DEPARTMENT OF TRANSPORTATION

> RE: Preliminary Plan No. 120230040 The Diener School Preliminary Plan Letter Traffic Impact Study (TIS)

Department of Permitting Services Fire Department Access and Water Supply Comments

> Re: COMBINED STORMWATER MANAGEMENT CONCEPT/SITE DEVELOPMENT STORMWATER MANAGEMENT PLAN for The Diener School 9312 Old Georgetown Road Preliminary Plan #: 120230040 Conditional Use Site Plan CU202306 SM File #: 288752 Tract Size/Zone: 106,613 sf/2.45 Ac./R-60 Total Concept Area: 85,273 sf/1.96 acres Parcel(s): P268, 1 and 2 Watershed: Rock Creek/Class I Type of Development: Redevelopment

Fire Department Access Review

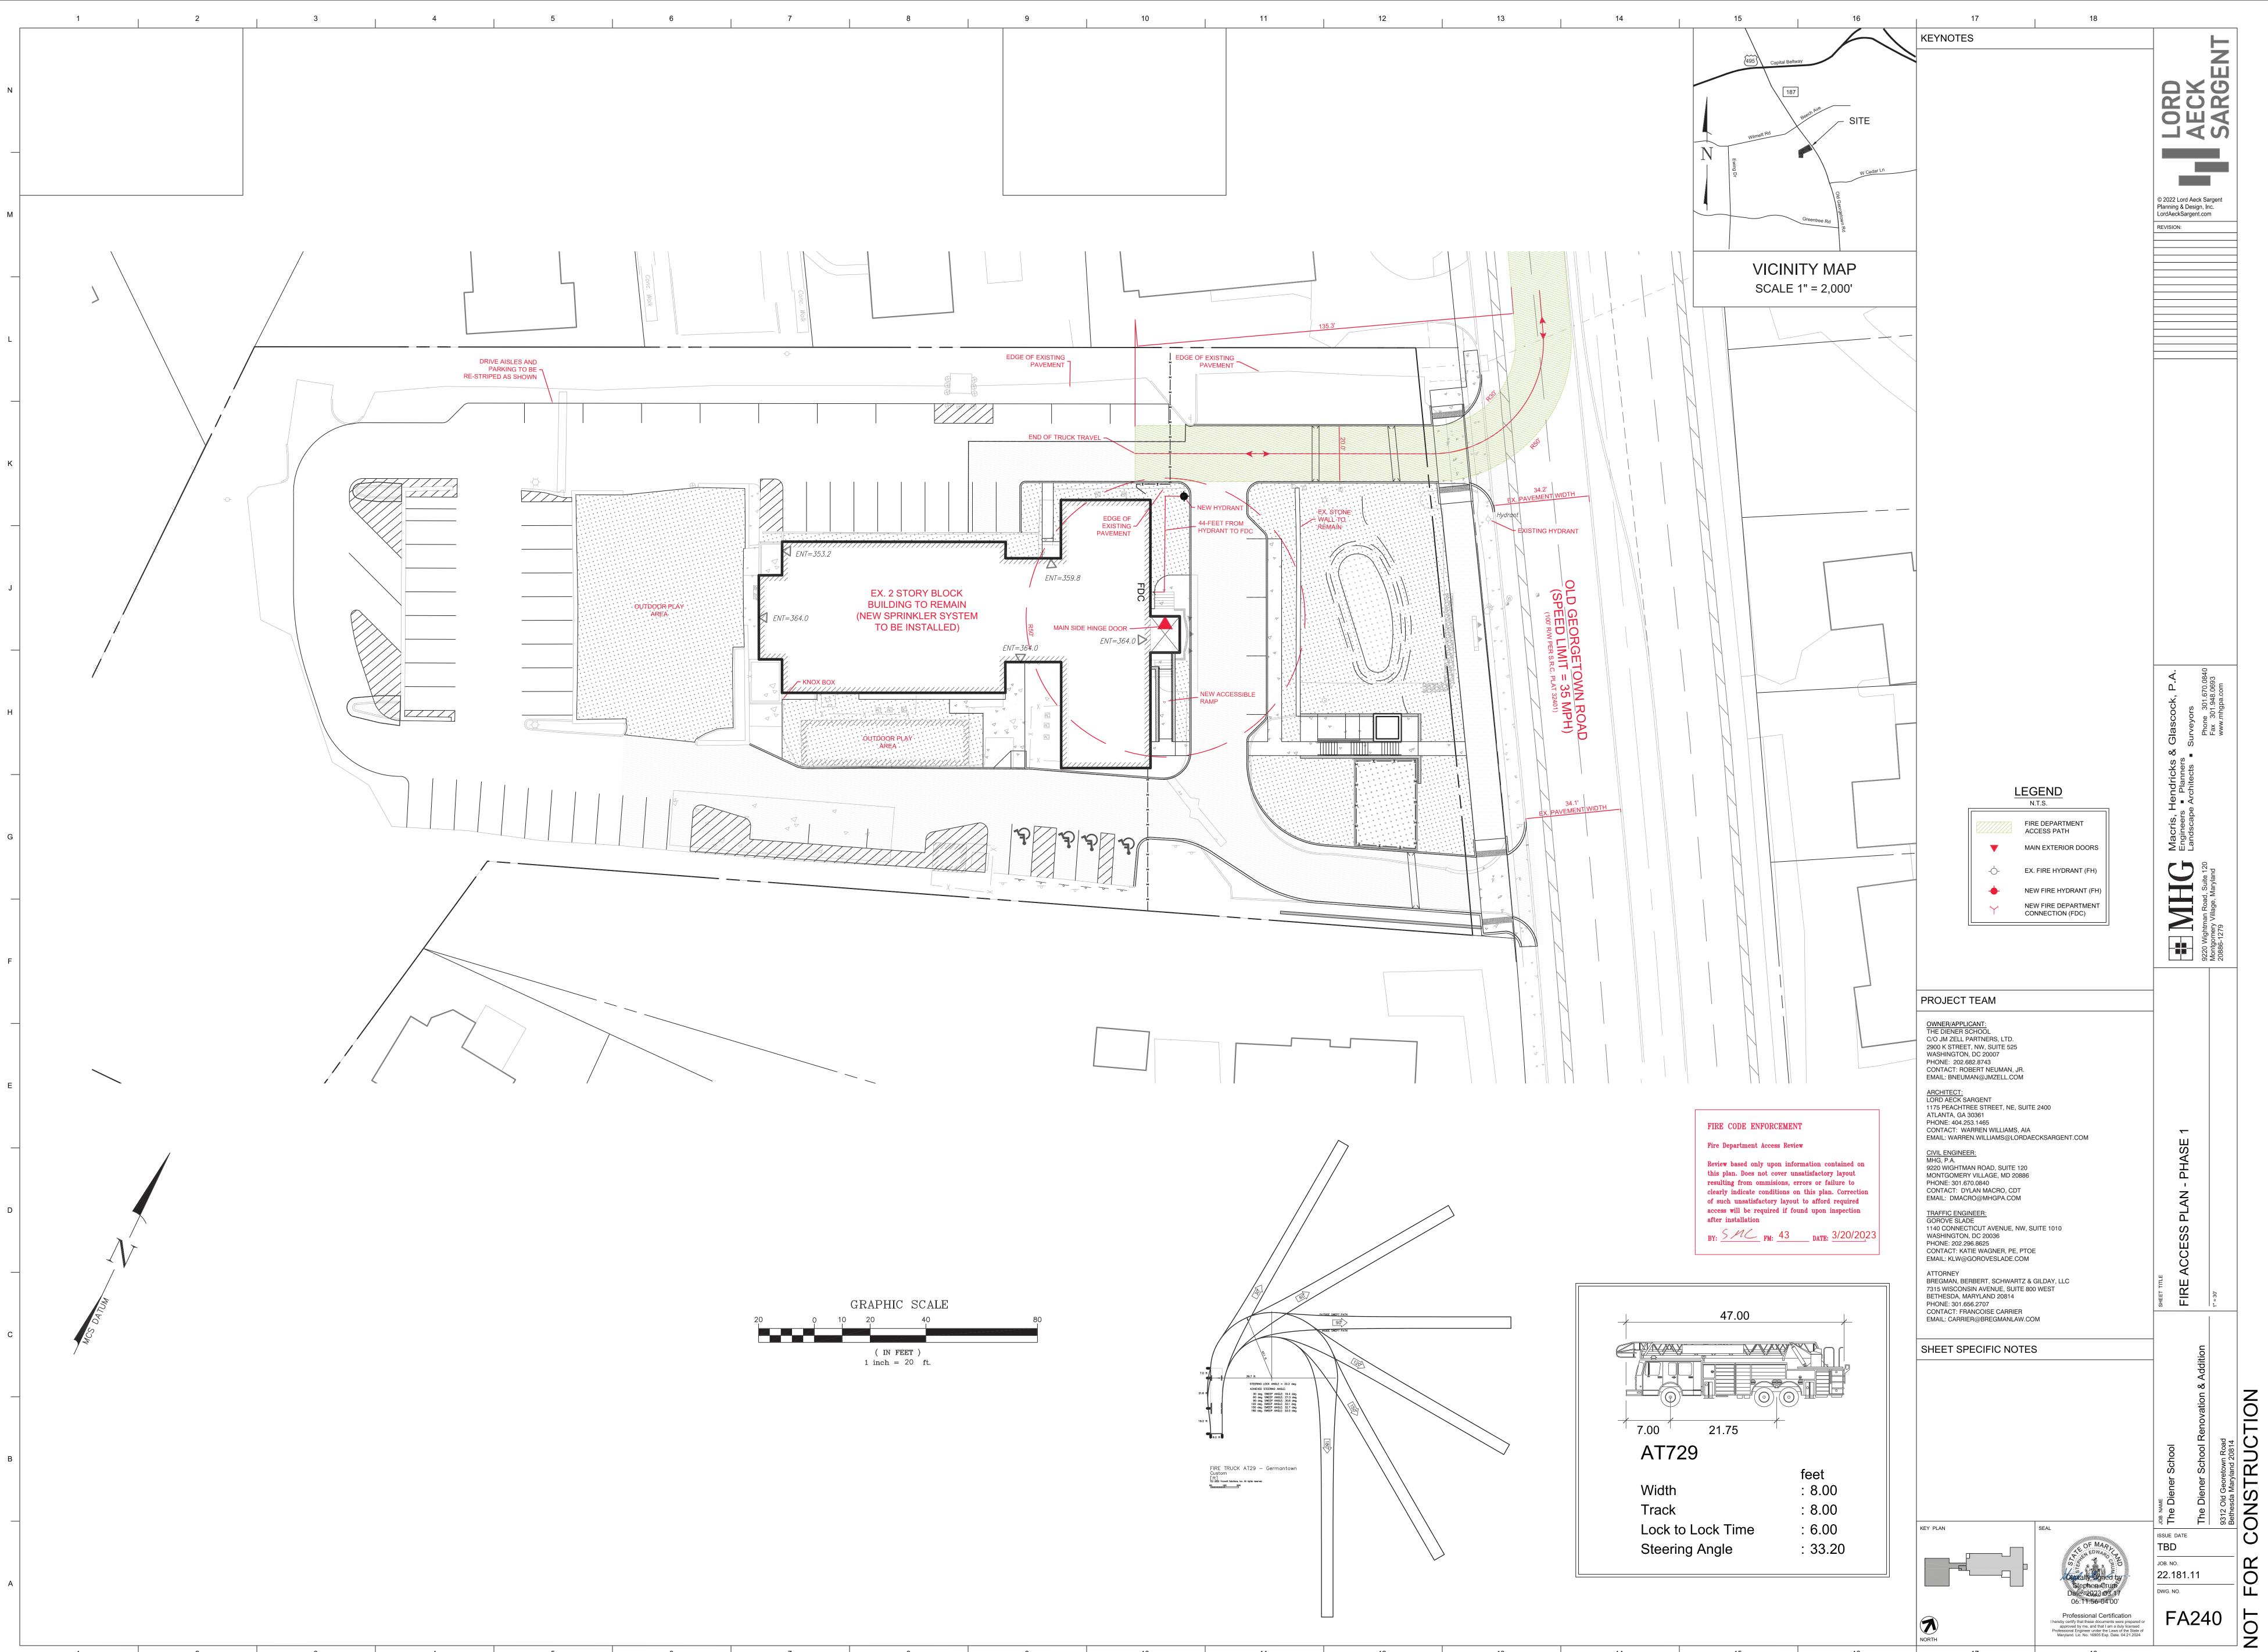
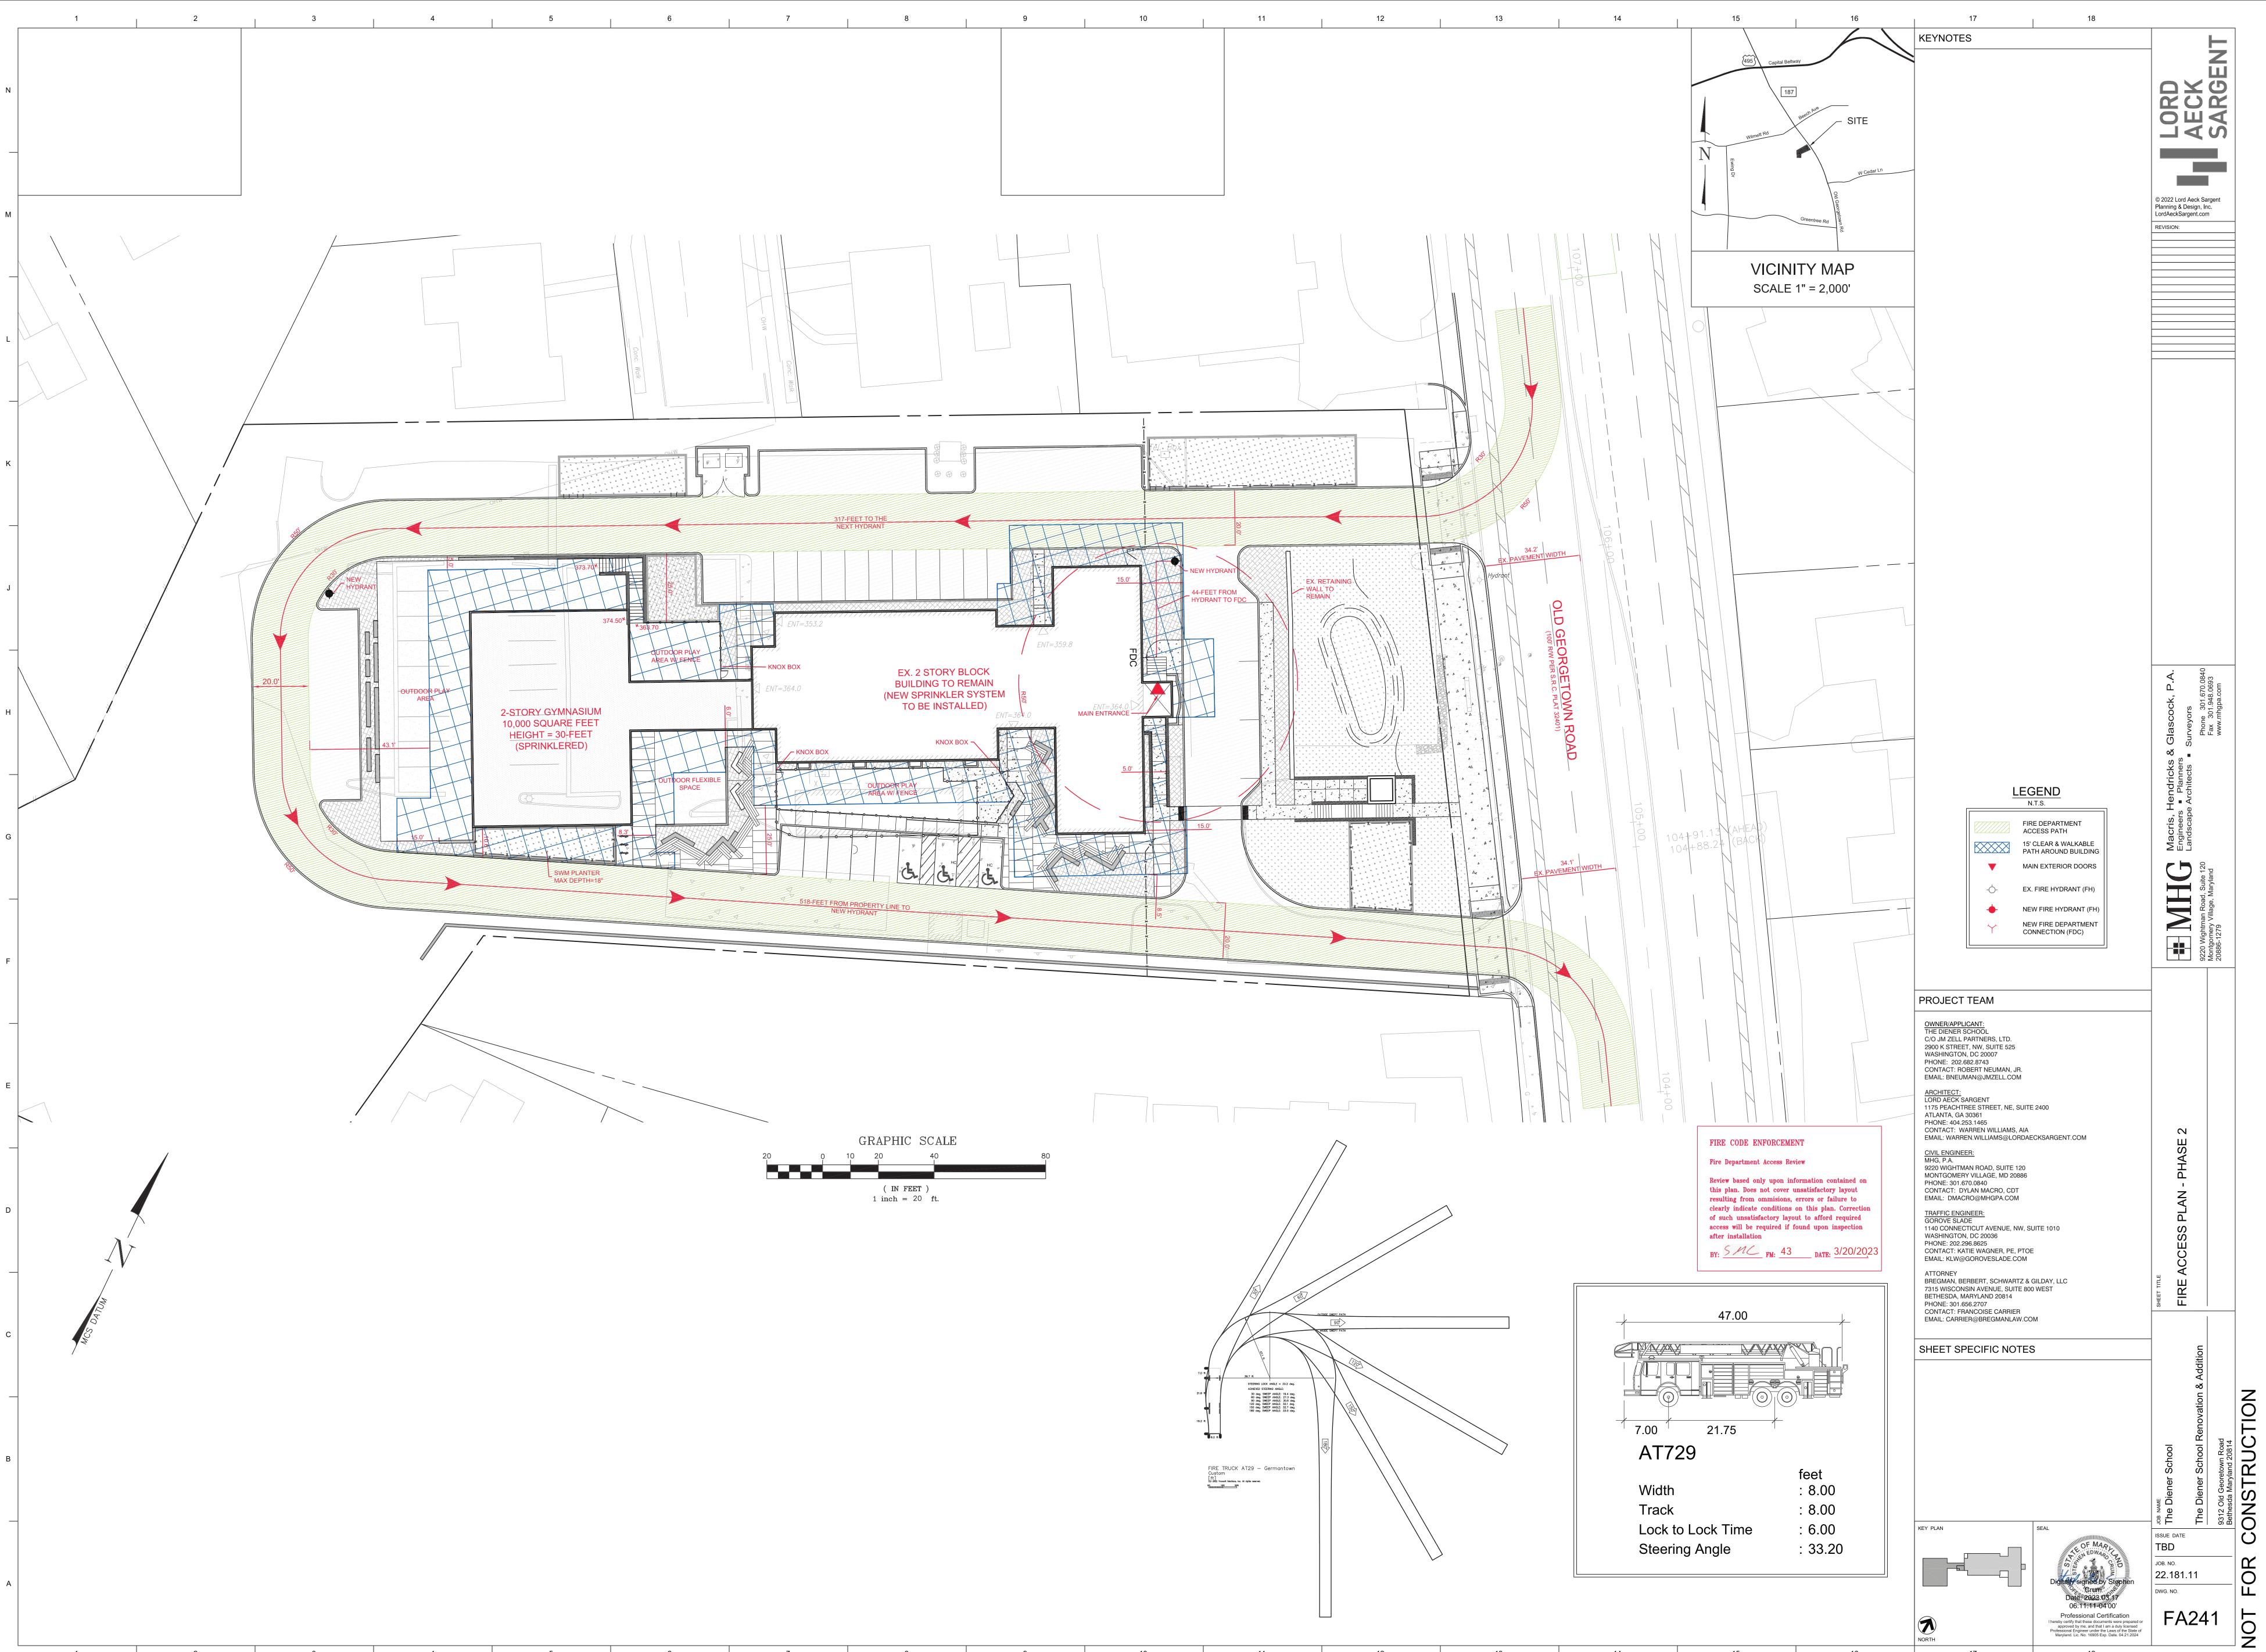
Review based only upon information contained on this plan. Does not cover unsatisfactory layout resulting from ommisions, errors or failure to clearly indicate conditions on this plan. Correction of such unsatisfactory layout to afford required access will be required if found upon inspection after installation

BY: <u>SMC</u> FM: <u>43</u> DATE: <u>3/20/20</u>23
